State	Project Number	Sheet No.	Total Sheets
GA	CSNHS-0006-00(043)

FINAL FOR REVIEW
2/22/11

GEORGIA DEPARTMENT OF TRANSPORTATION HIGHWAY DIVISION - BRIDGE DESIGN	
RIDGEWALK PARKWAY OVER I-575 CHEROKEE COUNTY	
REINFORCED EARTH RETAINING WALL	
PIANO WALL 1 ELEVATION	
DESIGNED <u>VG</u>	TRACED _____
DRAWN <u>VG</u>	CHECKED <u>[Signature]</u>
REVIEWED _____	APPROVED _____

PIANO WALL 1 ELEVATION - FRONT FACE
SCALE : 1" = 10'

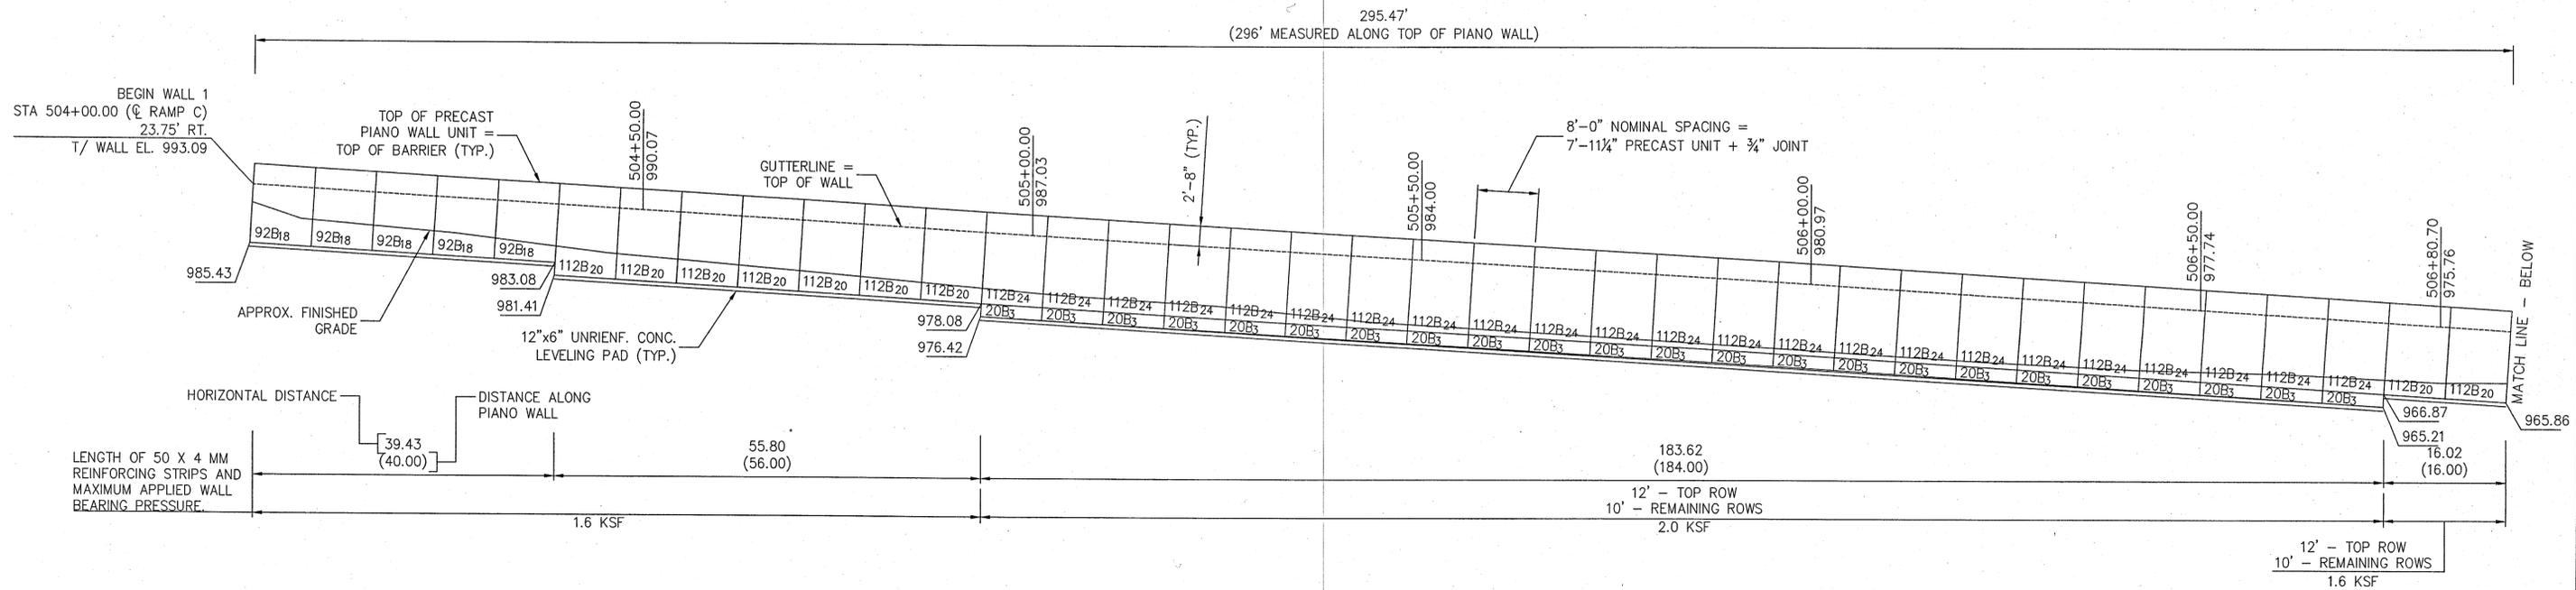
DATE: MAR 01 2011
Approved in general. Details not checked. This approval shall not relieve the Contractor of any responsibility for conformity with the contract Plans and Specifications.
Georgia DOT
Office of Bridge Design
By: [Signature]
